D350-822-011
Job Sheet 183945

DART SERVICE INSTRUCTION

TO AMEND INSTALLATION INSTRUCTIONS IIN-D350-822 REV. H AND INSTRUCTIONS FOR CONTINUED AIRWORTHINESS ICA-D350-822 REV. 6 OR LATER APPROVED REVISION

The purpose of this Service Instruction is to facilitate the replacement of the QD3072-46 Receptacles that are installed on the QB21308 Assembly Screen manufactured by Pall Aerospace as part of the D350-822-011/-013 PA100 PUREair System with the DSI 9815-011 Replacement Receptacle kit. The intent of this DSI has been incorporated into D350-822-011 at CHG 005 and D350-822-013 at CHG 003.

Figure 1 - QB21308 Assembly Screen

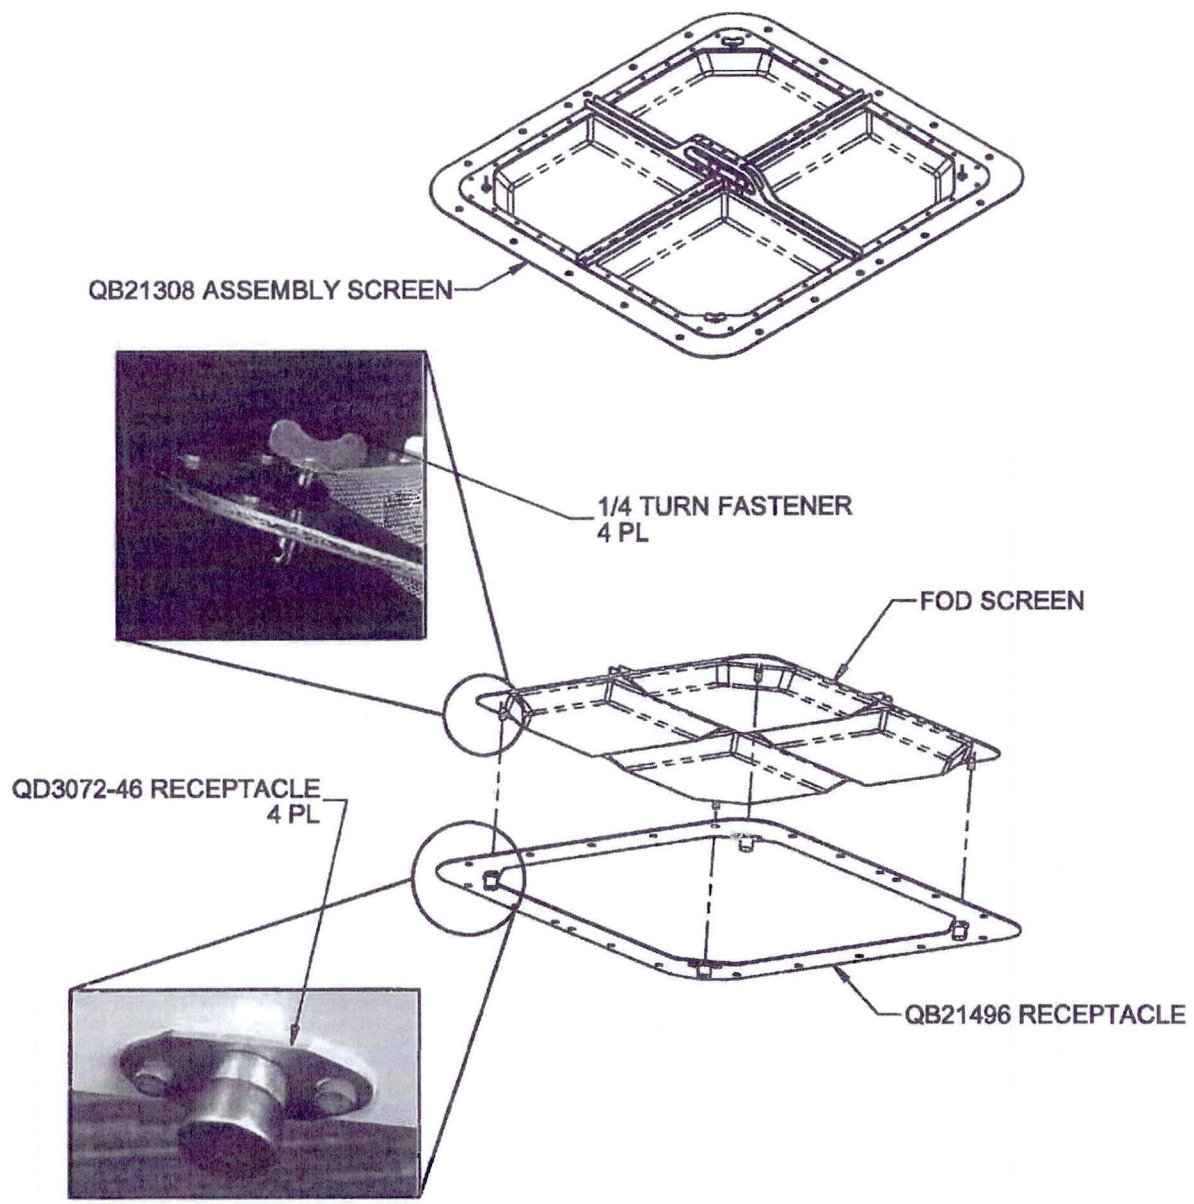
- 2.1.3 Separate the FOD screen from the QB21496 Receptacle by turning the 1/4 turn fasteners and lift the FOD screen per Figure 1.
 - 2.1.4 Drill out the retaining rivets and remove qty(4) QD3072-46 Receptacles from the QB21496 Receptacle. Remove any adhesive residue.

- NOTE: Although not generally necessary, it is acceptable to use longer or shorter MS20426AD3-X Rivets
- 2.1.8 Remove qty(4) 1/4 Turn Fasteners from the FOD Screen per Figure 1.

Figure 2 - DSI 9815-011 Replacement Receptacle Kit

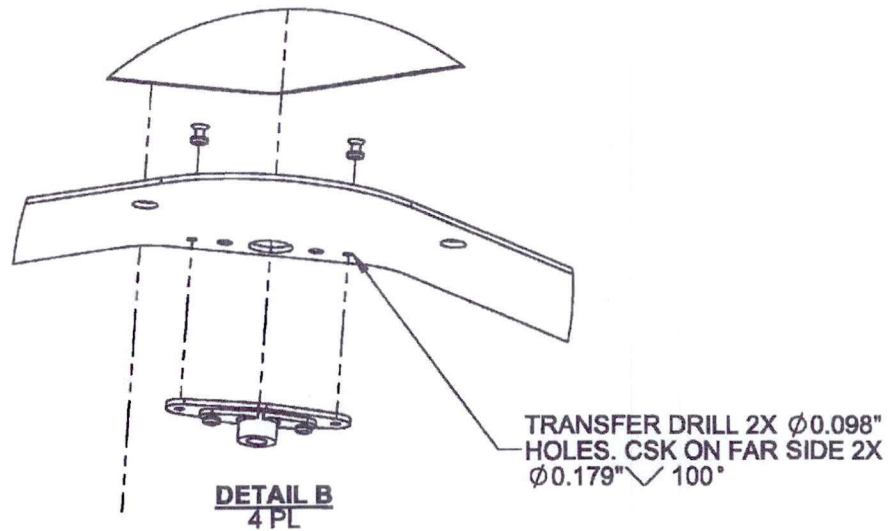
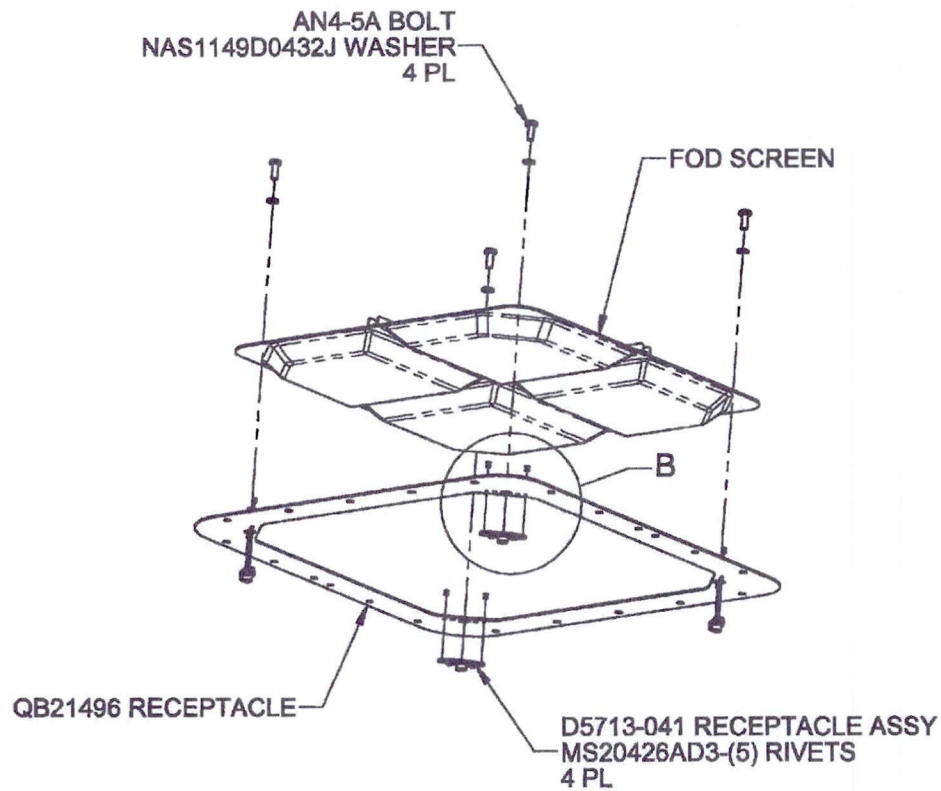
- 2.1.5 Position the qty(4) D5713-041 Receptacle Assy in the location shown in Figure 2. Transfer drill 2x $\phi 0.098$ " holes with CSK $\phi 0.179$ " $\angle 100^\circ$ on the top side from the D5713-041 Receptacle Assy to the QB21496 Receptacle. Touch up holes with Alodine 1200 per MIL-C-5541.

- 2.1.6 Mask nutplate holes and touch up the affected areas with prime and paint per ICA-D350-822.
 - 2.1.7 Install qty(4) D5713-041 Receptacle Assy with qty(2) MS20426AD3-(5) Rivets per Figure 2.

- 2.1.9 Reinstall the FOD screen on the QB21496 Receptacle using qty(4) AN4-5A bolts and qty(4) NAS1149D0432J Washers per Figure 2. Torque bolts to 50-70 in-lb (5.6-7.9 N-m).
